SUPAGAS
YES WE CAN!

NEW LCC27 VALVE CONNECTION

LCC27 VALVE + LCC27 APPLIANCE CONNECTION

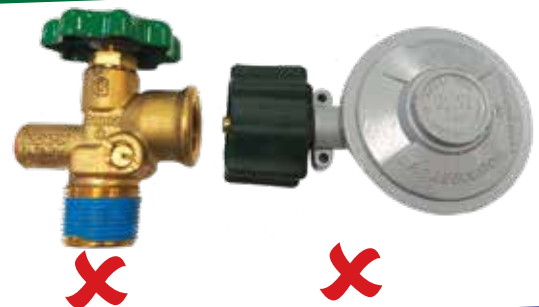
This connection combines the safety improvements of the valve and the appliance connection to provide the optimal safety benefits for the consumer.

TYPE 21 POL VALVE + LCC27 APPLIANCE CONNECTION

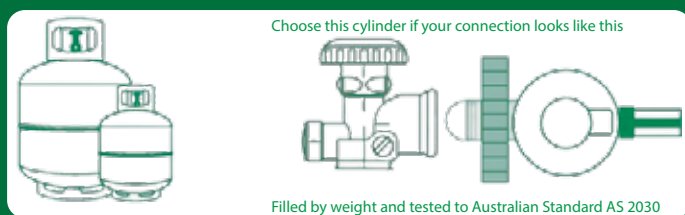
This connection is incompatible. Consumers should return to their SupaSwap supplier and exchange the Type 21 POL cylinder for an LCC27 cylinder.

TYPE 21 POL VALVE LABEL

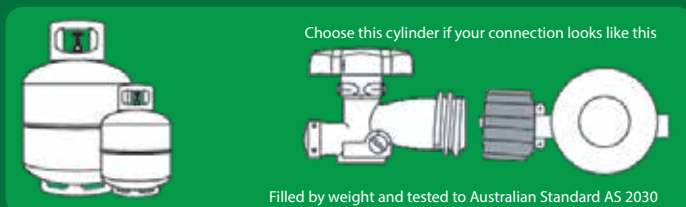
White background label with green print showing the Type 21 POL valve connecting to Type 21 POL appliance.
